**[Docket No. FAA-2023-0668; Project Identifier AD-2023-00199-R; Amendment 39-22453; AD 2023-11-07]**

#### **Airworthiness Directives; Various Helicopters**

**ACTION:** Final rule.

**Figure 1 to paragraph (g)(1)(i) – *Fundamental Effective Isotropic PSD at Outside Interface of Rotorcraft Antenna***

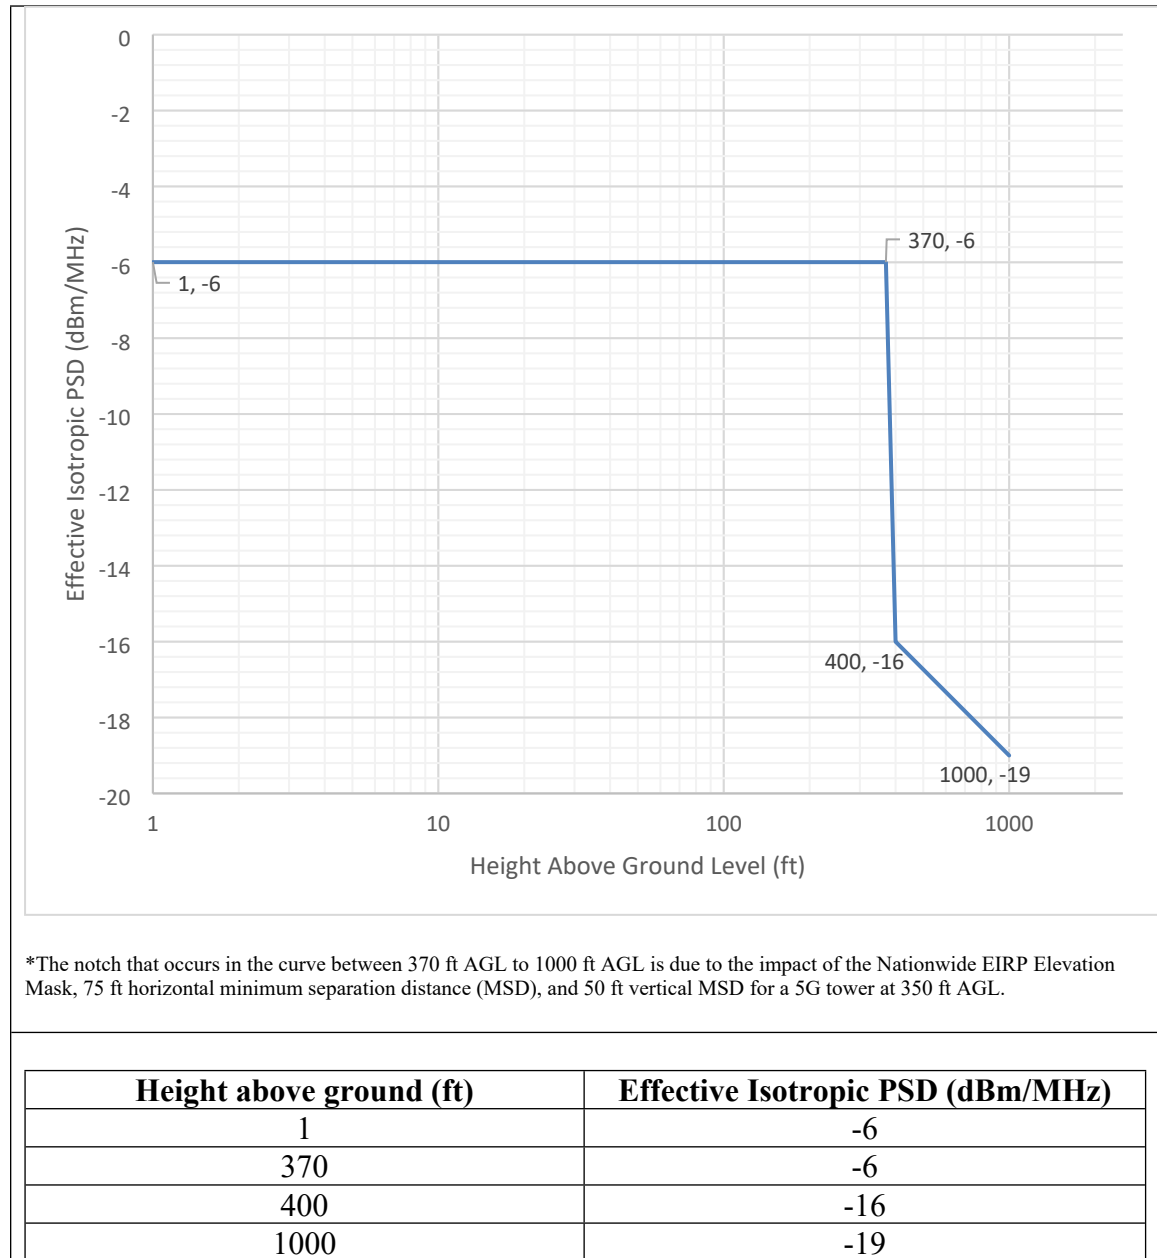
*Comment summary:* Thales and Sikorsky requested the FAA clarify several aspects of the PSD curve in figure 1 to paragraph (g)(1) of the proposed AD: whether no elevation mask is taken into account at and below 350 feet above ground level (AGL); at which base station emission power the PSD curve corresponds (62 dBm/MHz or 65 dBm/MHz); and whether the radio altimeter performance criteria in the curve explicitly covers any 5G emitter station up to 65dBm/MHz in the applicable 3.7–3.98 GHz band, for the foreseeable future. Sikorsky requested that the FAA revise the proposed AD to include a PSD curve that reflects the reduced EIRP levels for helicopters operating at the 188 priority airports (5G CMAs) with reduced power levels.

*Comment summary:* Sikorsky requested the FAA revise the PSD curve in figure 1 to paragraph (g)(1) of the proposed AD to change the height above ground at -6 dBm/MHz from 270 feet to 370 feet, and at -16 dBm/MHz from 300 feet to 400 feet. Sikorsky stated its request was based on several factors, including the minimum safe obstacle avoidance distance and the typical decision height used for radio altimeter critical operations associated with missed approach points (MAPs) during point in space (PINS) approaches. Sikorsky further stated that radio altimeters are not operationally used above 1000 feet, and therefore there is little value for any PSD restrictions above 1000 feet operationally.

*FAA response:* The notch in the PSD curve does not mean that no elevation mask is taken into account below 350 feet AGL. The elevation mask is taken into consideration below 350 feet AGL and is a fundamental consideration in how the PSD curve was established. The PSD curve was calibrated to cover 5G C-Band emitter stations up to 65 dBm/MHz in the applicable 3.7-3.98 GHz band.

The FAA disagrees with revising the AD to include a PSD curve for helicopters operating at airports with reduced power levels. The radio altimeter tolerant rotorcraft

PSD curve was established to provide safe operation anywhere in the contiguous U.S. regardless of whether a helicopter is operating at a 5G CMA.

*FAA response:* The FAA assumed an emitter base station height of 350 feet based on consensus reached in rotorcraft industry group meetings. Additionally, FAA analysis of existing emitter base station height data shows that, while higher emitters do exist, they are infrequently adjacent to helipads. Second, the FAA assumed the rotorcraft was no closer than 50 feet above and 75 feet laterally from the emitter. The vertical distance was based on pilot feedback and the lateral distance was based on common lateral separation from the main rotor tip recommendations of 2 main rotor diameters from the tip of the rotor, selecting a 30 foot rotor as the smallest rotor in this class of aircraft with the antenna under the main rotor mast. An operator of an individual model rotorcraft with a larger rotor diameter may request approval of an AMOC to the AD on the basis of separation distance. Third, the FAA assumed that the emitter was active at the full rural power level of 65 dBm/MHz allowed in FCC Report and Order FCC 20-22.<sup>2</sup> The FAA then evaluated the resulting curve against data from radio altimeters and found it to be

achievable with current technology using filters that have been developed. Based on data from existing emitters, if the height reduction from 370 feet to 270 feet, as requested by the commenter, were adopted, it would result in many more landing scenarios unprotected from interference because emitters on towers at about 250 feet as opposed to the accepted assumption of 350 feet are much more common. For this reason, the FAA did not adopt this request.

The FAA has re-evaluated the need for PSD performance requirements above 1000 feet and agrees with the reasons provided by the commenter. The PSD curves specified in this AD have been changed accordingly.

**Figure 2 to paragraph (g)(1)(ii): Spurious Effective Isotropic PSD  
at Outside Interface of Rotorcraft Antenna**

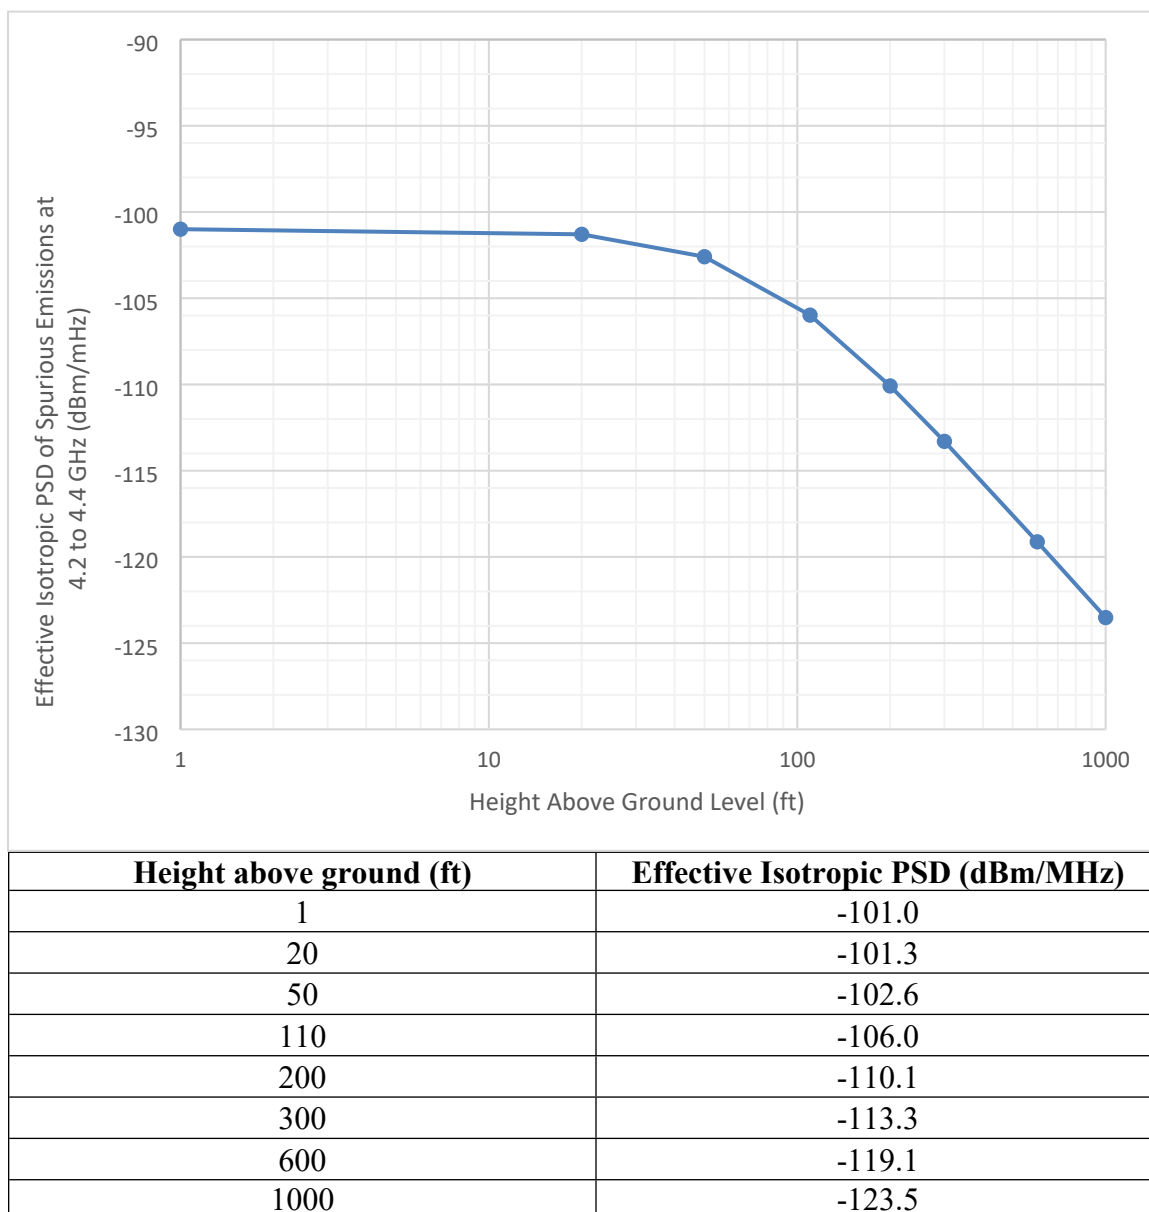
*Comment summary:* HAI, Sikorsky, and Thales requested that the FAA revise the proposed AD to include the frequency range to which the PSD tolerance curve thresholds apply, a new figure indicating the spurious tolerance similar to the figure with the PSD tolerance curve, and a specification of the altitude dependence for spurious tolerance.

*FAA response:* The FAA agrees and has added the frequency range to the PSD tolerance curve and replaced the proposed fixed emission level with a spurious PSD tolerance curve.
